MAZDA DEALER EMAIL

Subject: **Launch of Safety Recalls: 3319E 2019 Mazda3 Indicator Concern and 3519F - 2019 Mazda 3 Wheel Lug Nuts Loosening Concern**

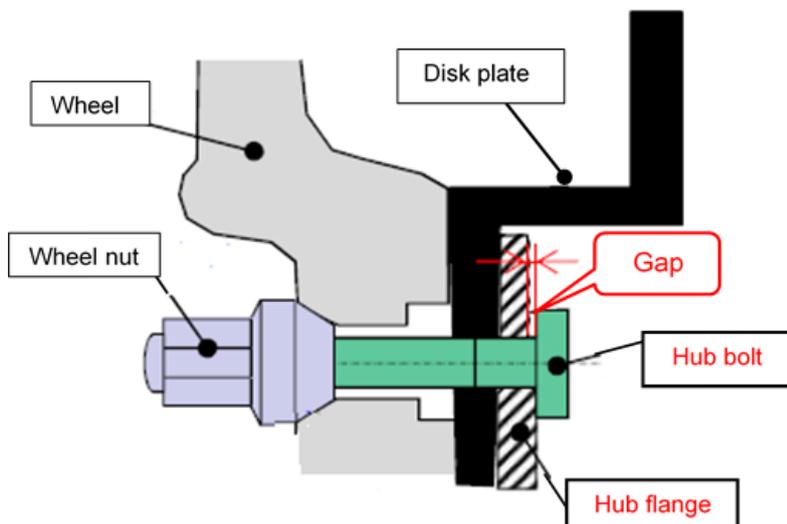
On certain subject vehicles, the wheel lug nuts may loosen and fall off during normal driving. Continuous use in such condition may lead to a wheel falling off the vehicle and there could be a loss of vehicle control.

A manufacturing process error may create a partial gap between the hub bolt head and hub flange during assembly. This gap may cause a loss of torque and eventual loosening of the wheel nut if they were tightened prior to proper seating of the hub bolt, even though they were tightened to the correct specification at the plant.

Retighten the front and rear wheel nuts with 137Nm (101 ft. lb.) to 147Nm (108 ft. lb.).
